Access Compliance Report

Public Rights-of-Way

(Pedestrian Signals)

Intersection ID: N/A	Main Street:	Cross Street: N/A	Location: N/A
ADA ID: 3D19DD16C6C3	Signal Type: One Push Button-APS	Overall Compliance: No	Severity Score: BTN 1: N/A BTN 2: N/A No BTN: N/A
Codes/Mitigation Info/Possible Solution		Field Measurements/Component Compliance

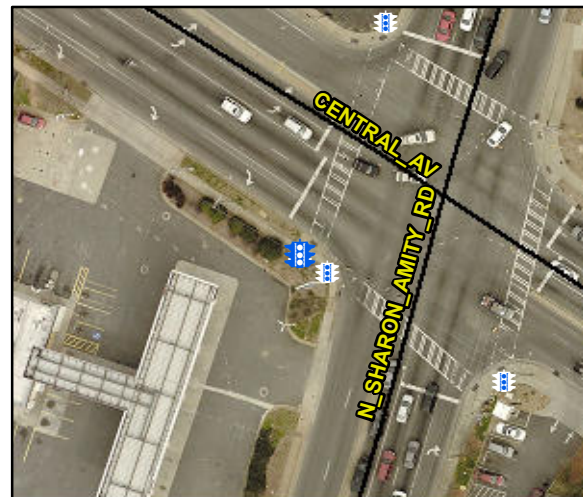
Surveyor Notes: TEXT HT 3/8, SIGNAL IS OUT OF SERVICE

PROW/ADA: R410.6, TMUTCD 4e.08, R404.2, R403.4, R209.1, TMUTCD 4e.10, MUTCD 4e.08, R104.2,

Possible Solutions: Replace Signal Push Button With APS Button on New Post. Remove & Replace Sign.
